16710/P019275  
Serial: C1-1500200  
January 16, 2015

Subj: NEW CONSTRUCTION, CG1323256, Conrad Orange Shipyard Hull No. H-483  
NEW CONSTRUCTION, CG1323257, Conrad Orange Shipyard Hull No. H-484  
200' x 35' x 12'-6" Unmanned Double Hull Type I/II/III Tank Barges (D/O)  
Grade A (max. 25 psia Reid) and Lower Flammable or Combustible Liquids Identified in  
46 CFR Table 30.25-1 or 46 CFR Part 153 Table 2 and Specified Hazardous Cargoes  
Design Density 8.7 lbs/gal; Maximum Density (slack load) 12.91 lbs/gal  
Rivers; Lakes, Bays, and Sounds; Limited Coastwise on unmanned fair weather voyages  
only, not more than 12 miles offshore between St. Marks and Carrabelle, Florida  
Vapor Collection System and List of Authorized Cargoes

Ref: (a) Conrad Industries Co., Dwg. No. H-483-P5, Rev. No. 3, "Vapor Recovery Piping  
Arrgt.," Sheet 1 of 2, dated November 24, 2014  
(b) Conrad Industries Co., Dwg. No. H-483-P5, Rev. No. 2, "Vapor Recovery Piping  
Arrgt.," Sheet 2 of 2, dated December 10, 2014  
(c) Guarino & Cox, LLC, "Vapor Control System Calculations," Rev. No. 0, dated  
November 3, 2014

Graphs as required by 46 CFR 39.30-1(b)(3)

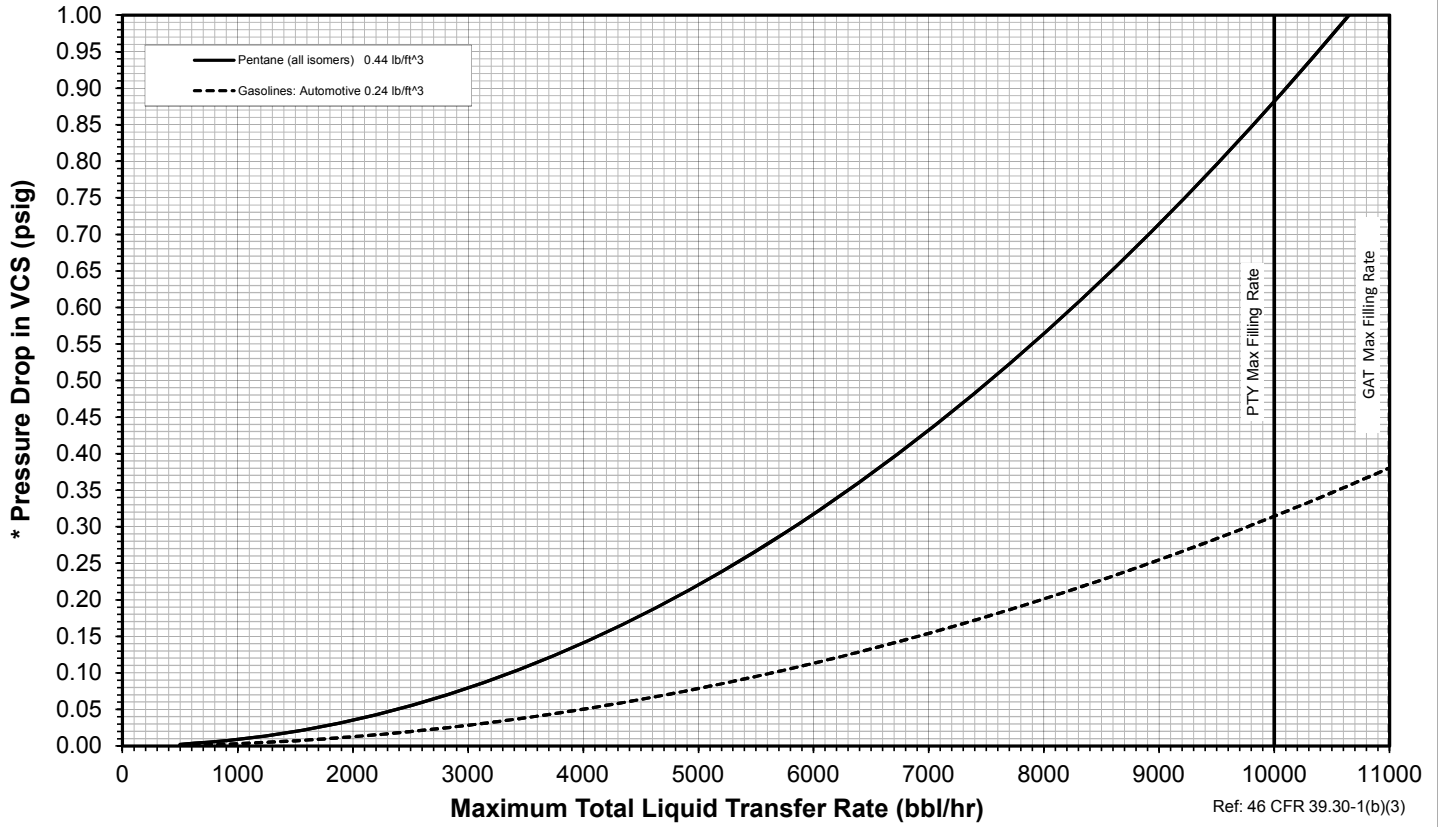
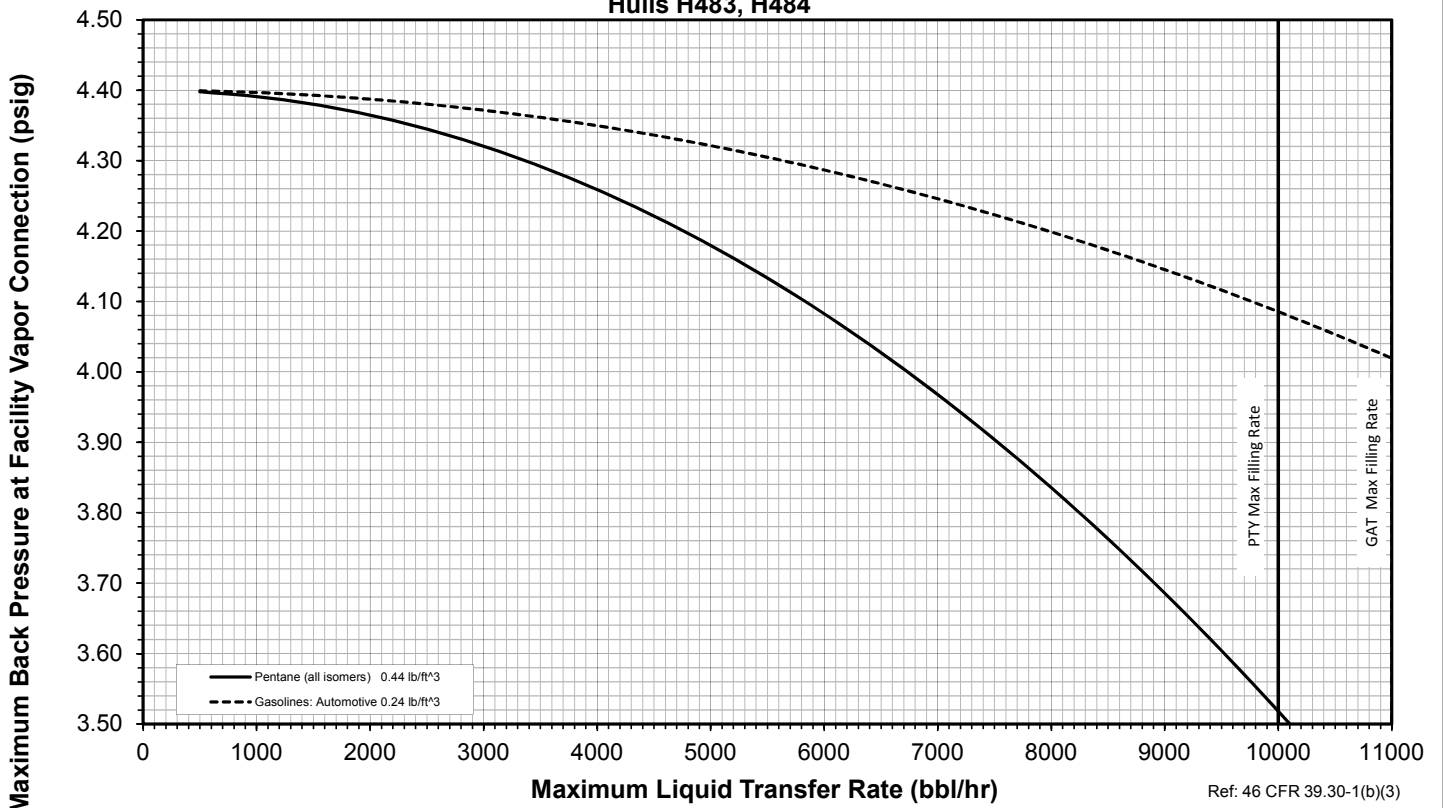
3. The oil transfer procedures shall include a table or graph showing the liquid transfer rate versus the pressure drop, as required by 46 CFR 39.3001(c)(4). This information must be taken from the calculations, tables, and graphs contained within reference (c).
